CONVAIR

COMMERCIAL CHANGE PROPOSAL

SPEC NO.: ZD- 22-002

MODEL: 22-1 (Convair "880")

FULL FIRST CLASS SEATING ARRANGEMENT
WITH CLUB AREA

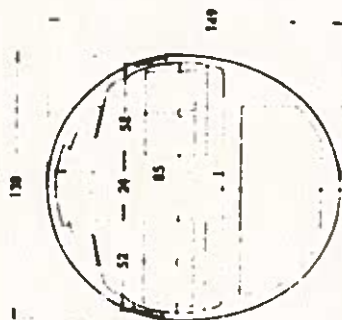
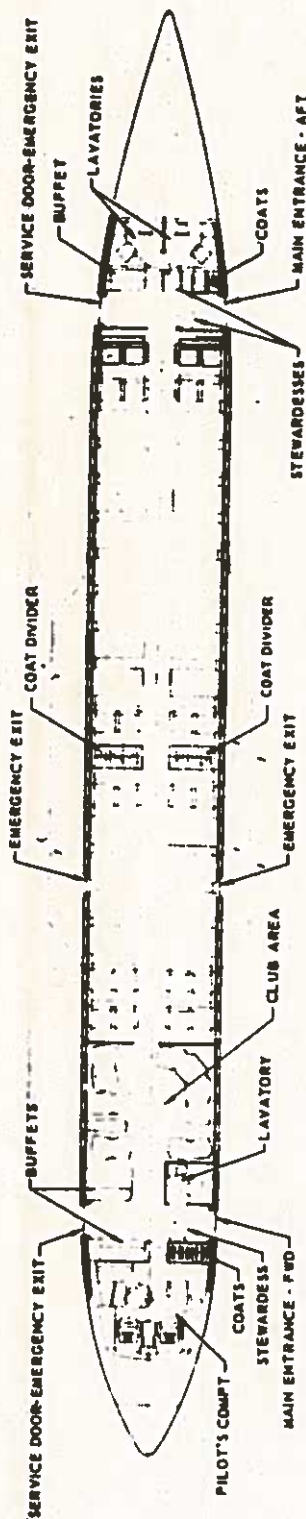
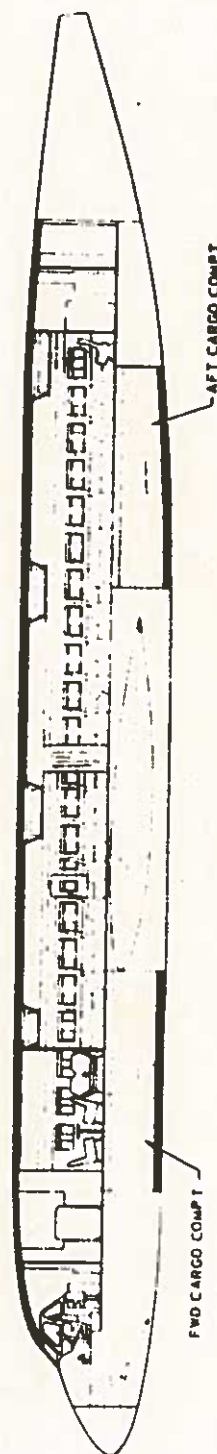
Above illustration will be revised to show movable coat dividers installed in eighth from aft row with seven triple and seven double coach installed aft of the coat dividers. The title will be revised as follows:

Page 6B, C. G. DESIGN LIMITS:

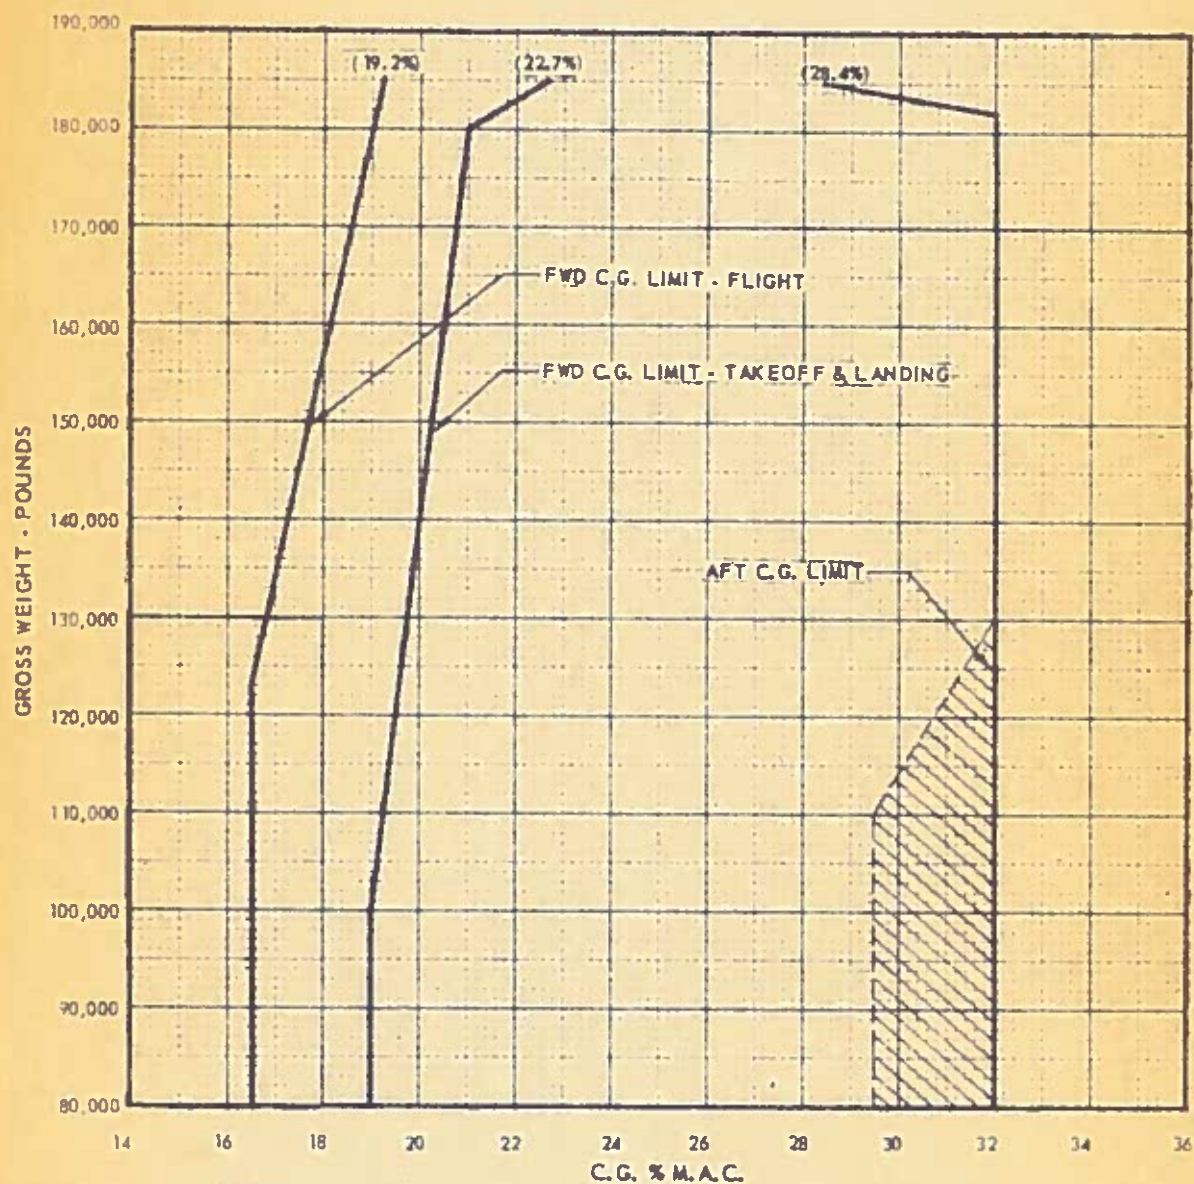
Replace above graph in specification with Enclosure (A):

Enclosure: (A) One copy Page 6B - C. G. DESIGN LIMITS (Revised)

FWD. ENTRY COMPARTMENT

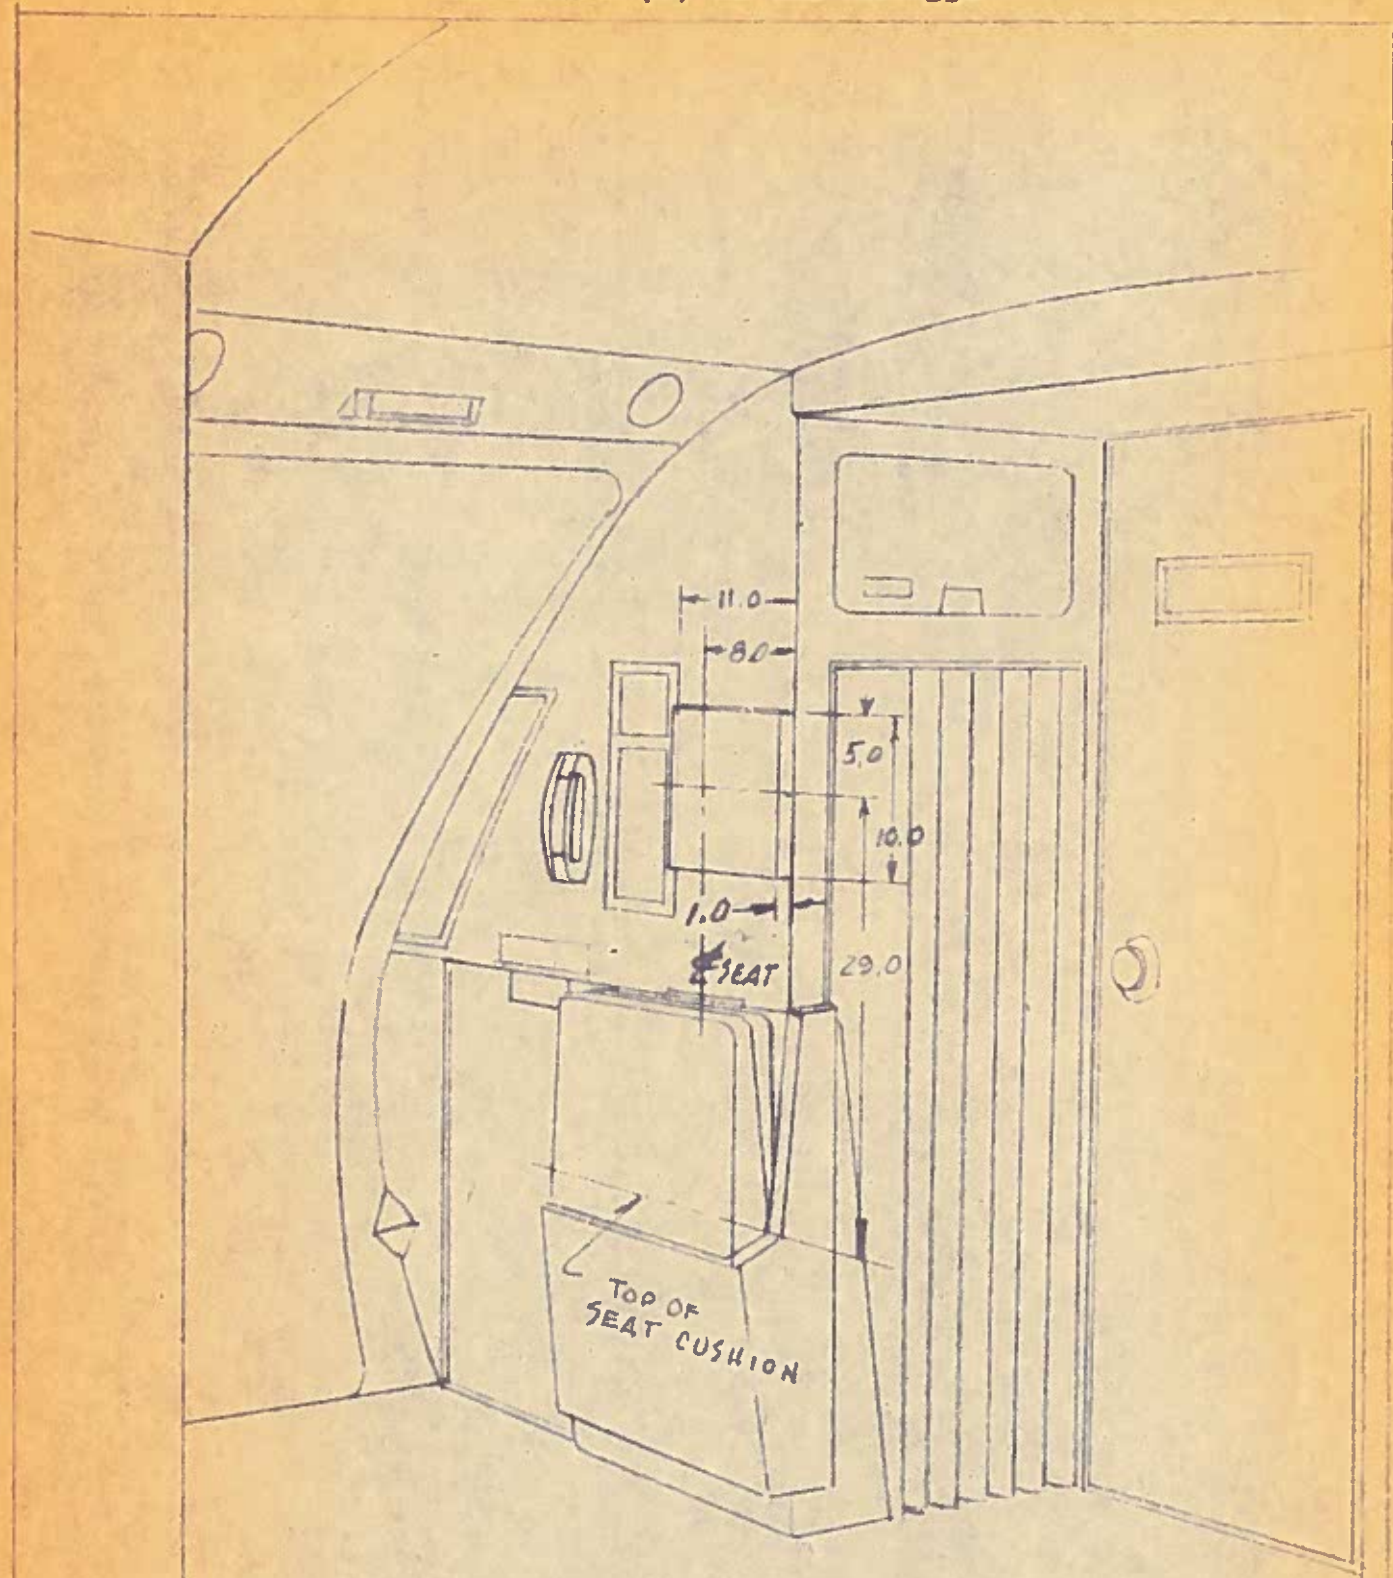
Add the following to the end of the paragraph:

"An upholstered, detachable head rest shall be installed, one each on the aft face of the forward left hand coat compartment and on the left hand aft bulkhead for use of the aft facing cabin attendants."

ENCLOSURES: (A) Convair Sketch - HEAD REST, ATTENDANT SEAT, FWD.
ENTRY COMPARTMENT (For information only.)

AFT ENTRY COMPARTMENT

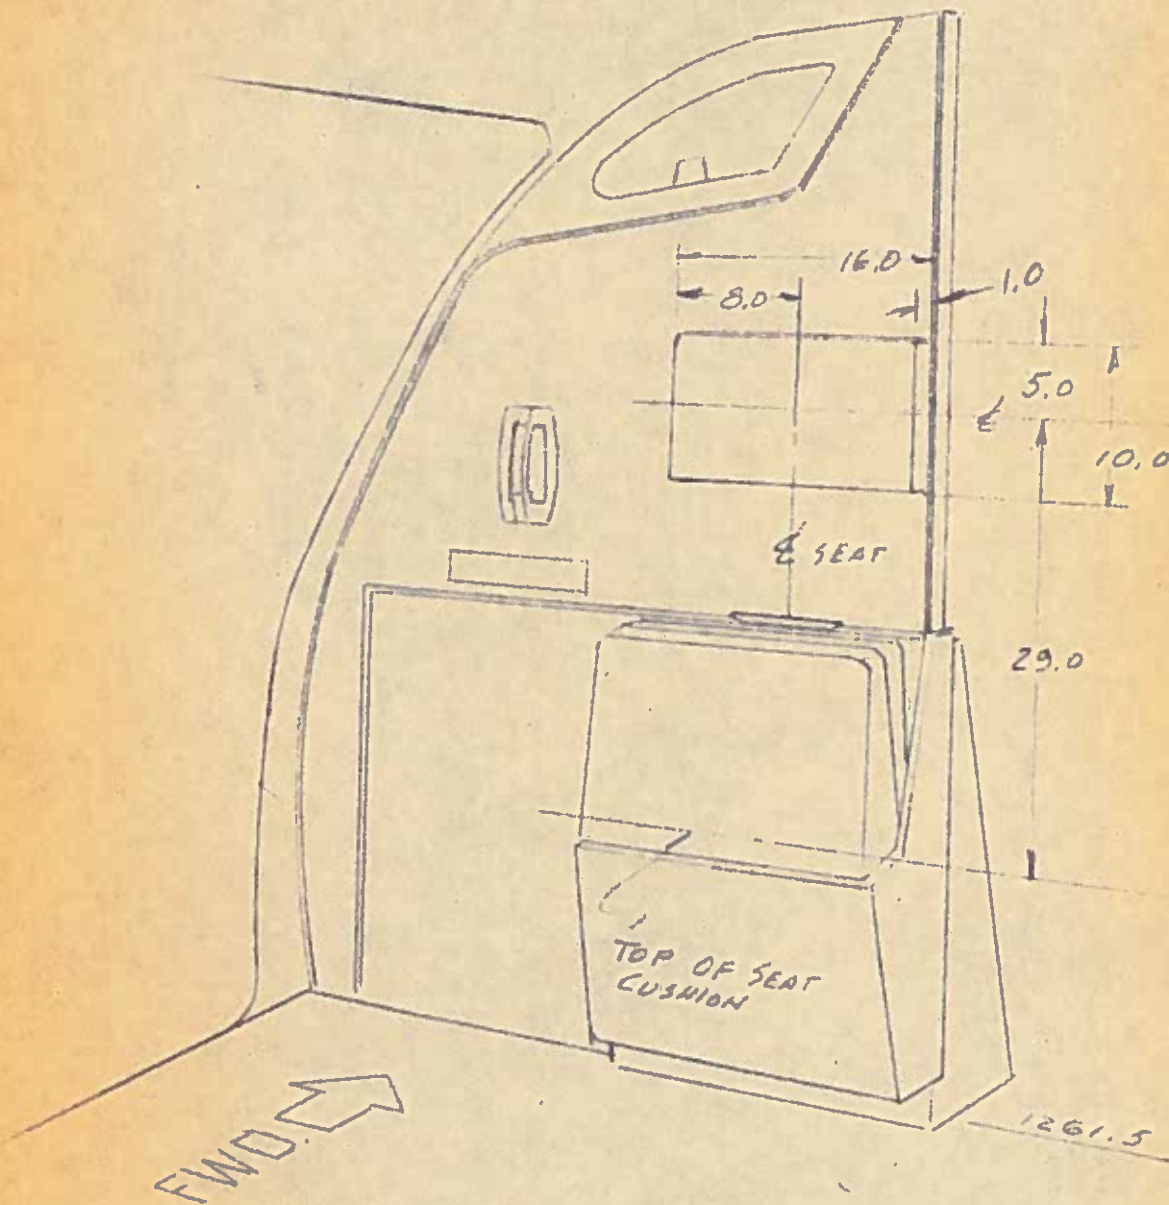
(B) Convair Sketch - HEAD REST, ATTENDANT SEAT, AFT
ENTRY COMPARTMENT (For information only.)

Page 6B, CENTER OF GRAVITY LIMITS

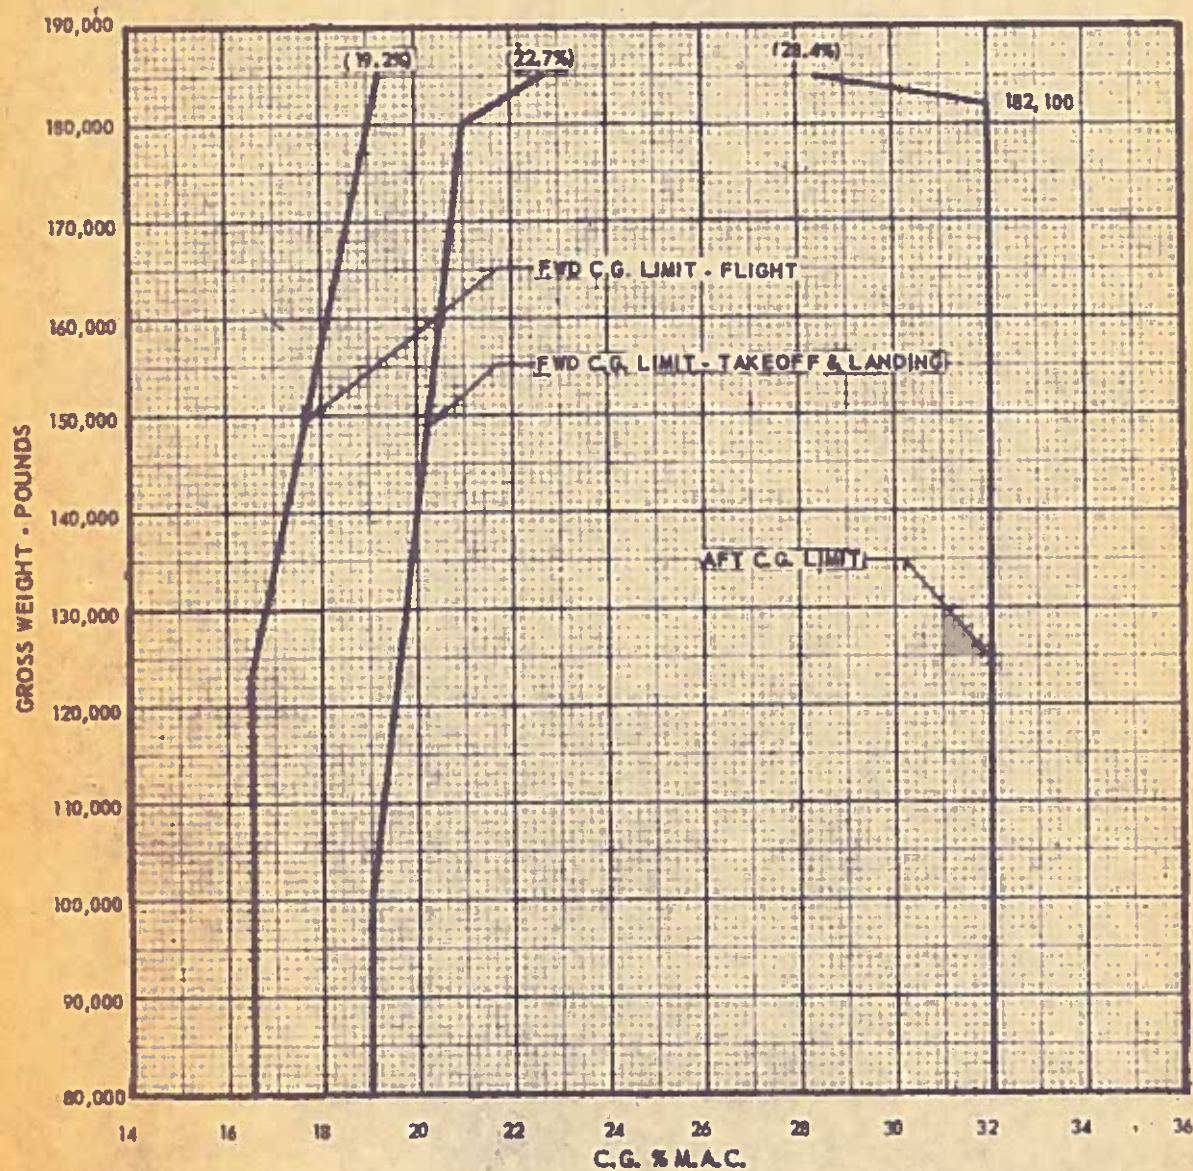
Reason for Change: To incorporate an up to date Center of Gravity Limits Graph into specification.

Enclosure: (A) One copy Convair Sketch - 52" SEAT (For information only)

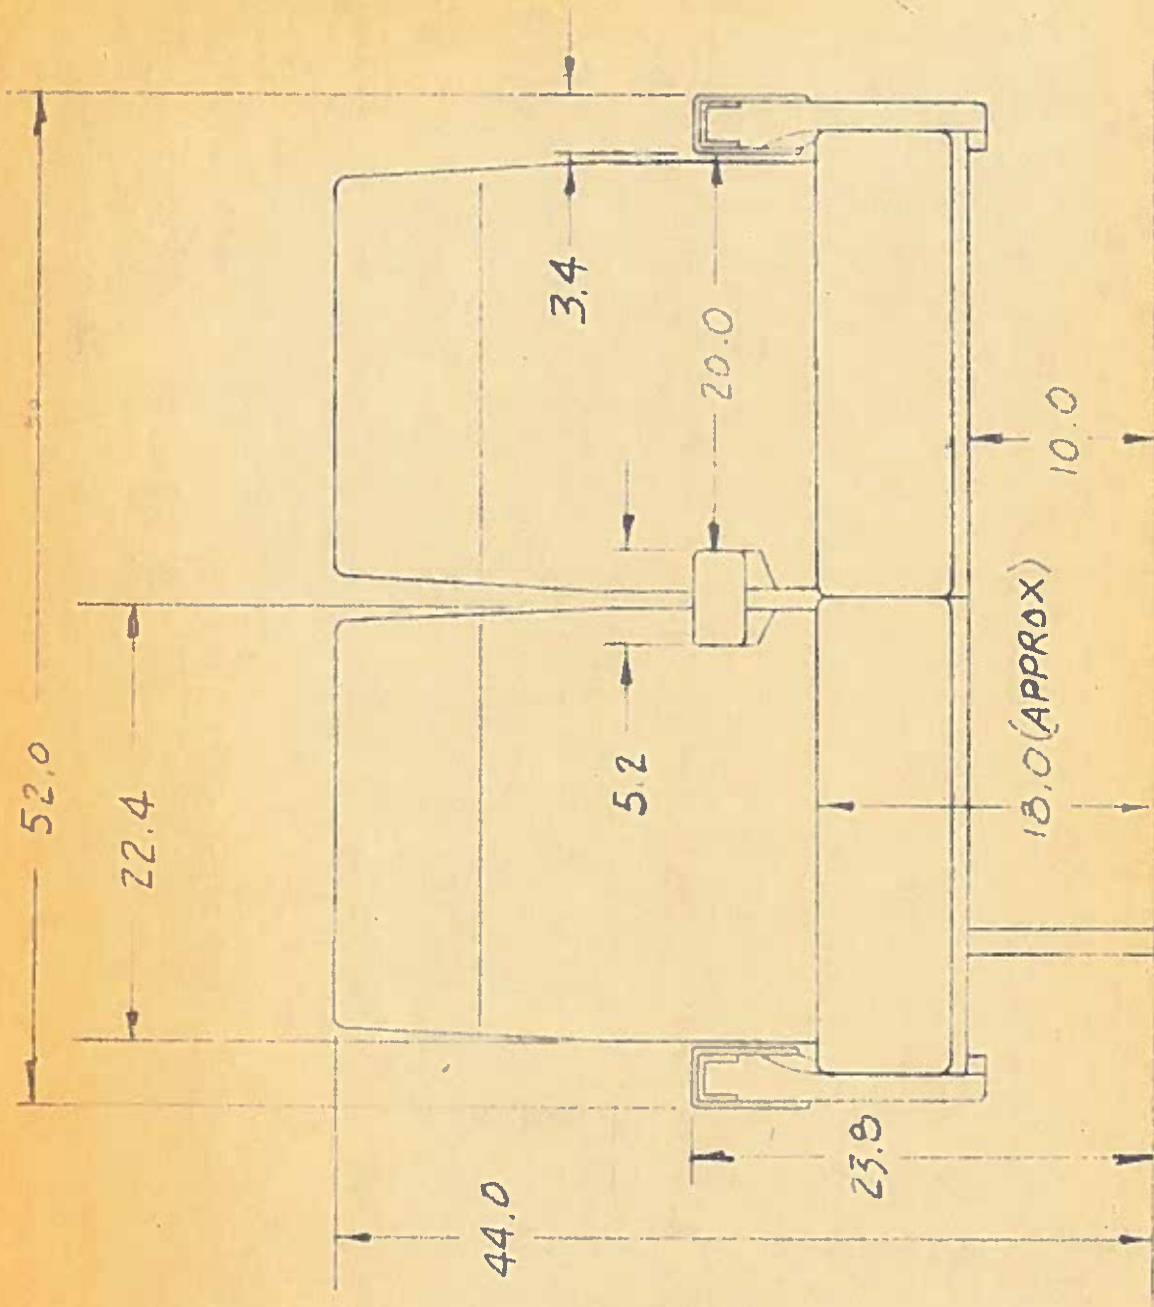
Add the following to the bottom of Page 129"

"**NOTE: Seat back covers are interchangeable between all L.H. and R.H. double-seat positions. Seat covers are interchangeable between corresponding positions on L.H. and R.H. double seats."

Page 126A, FIGURE 3.20-1 AIR CONDITIONING AND PRESSURIZATION SYSTEM:

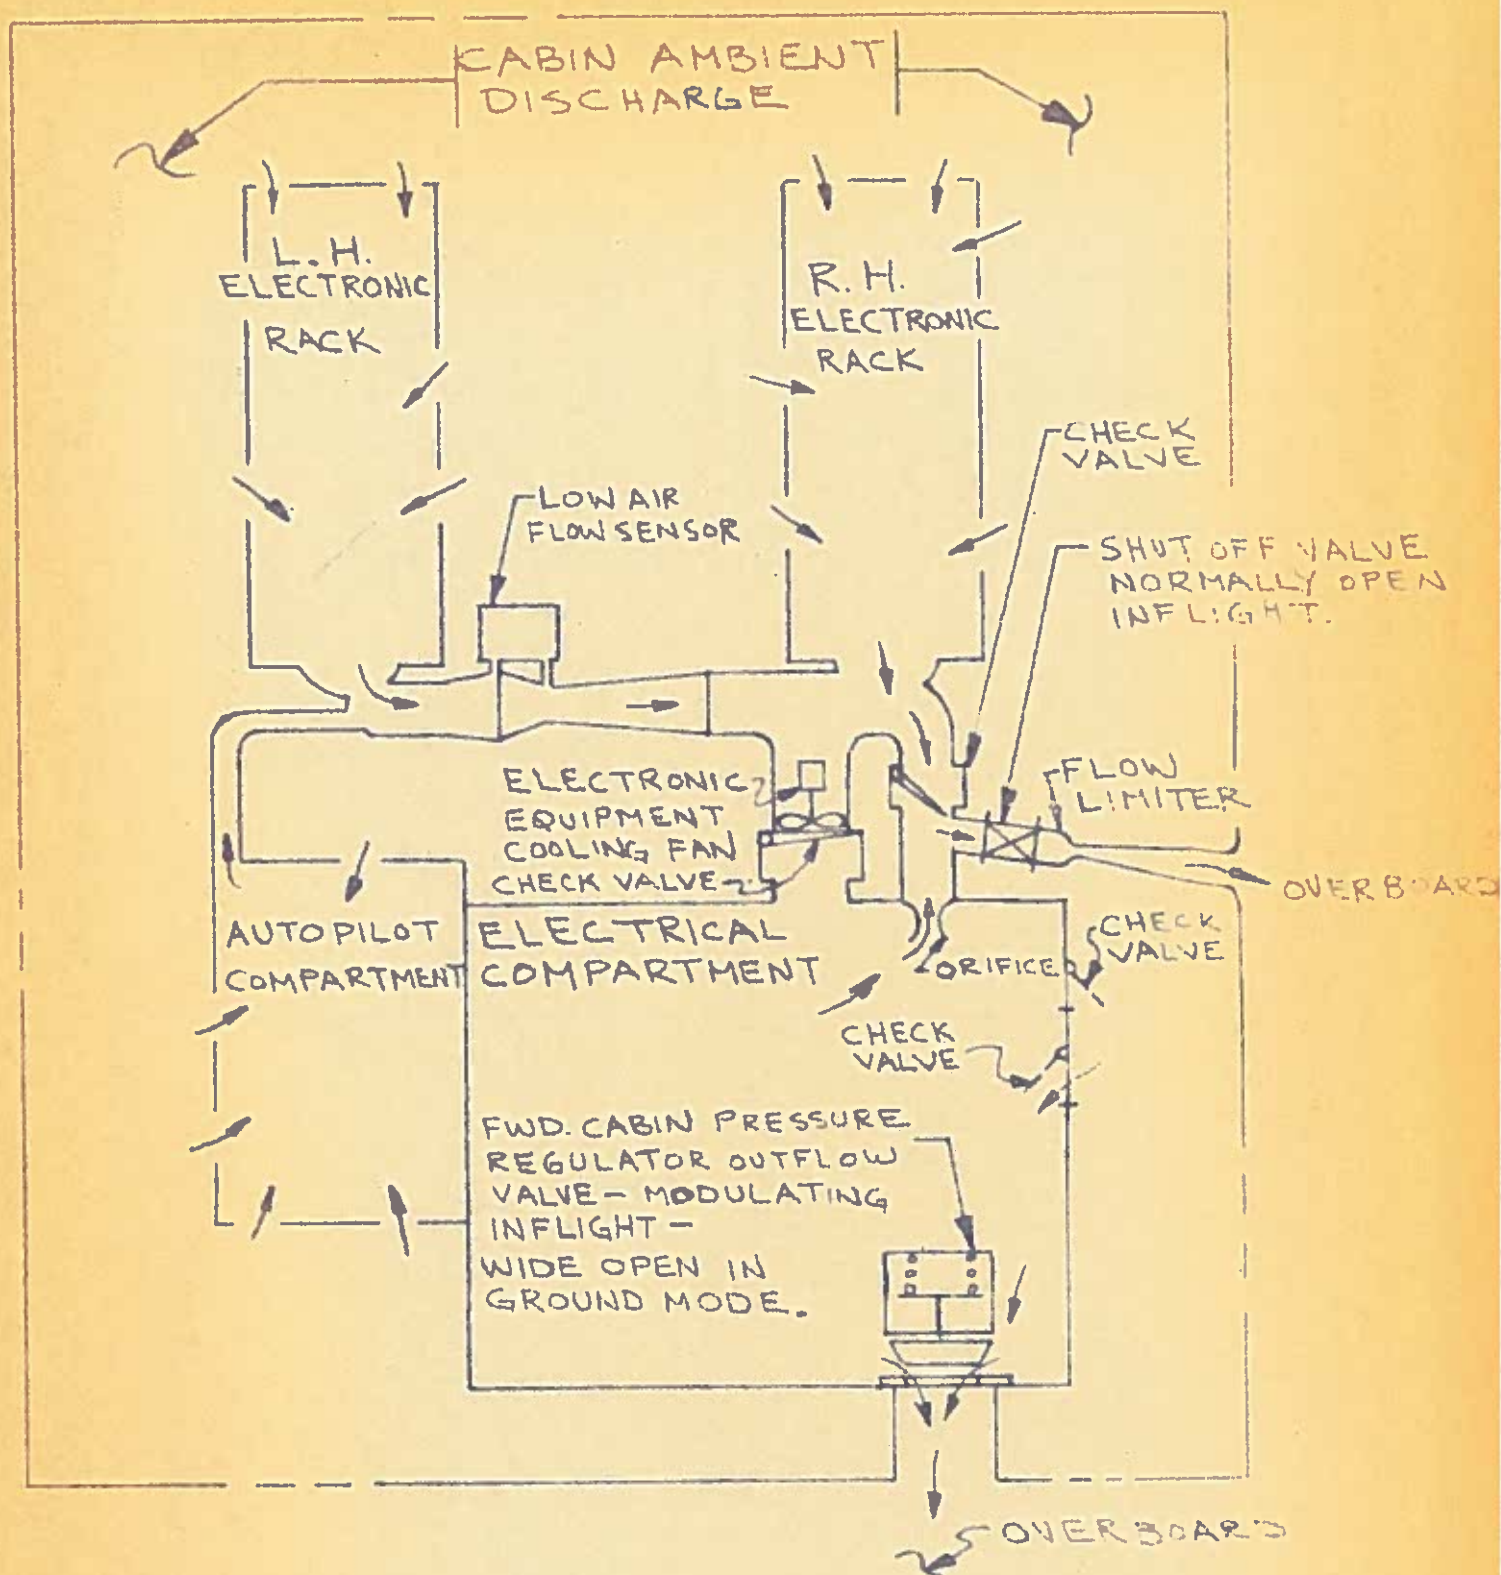
Above illustration to be revised to show the effects of this proposal.

Enclosure: (A) One copy Convair Sketch - AIRFLOW PATTERN SHOWN FOR NORMAL INFLIGHT MODE (For information only)
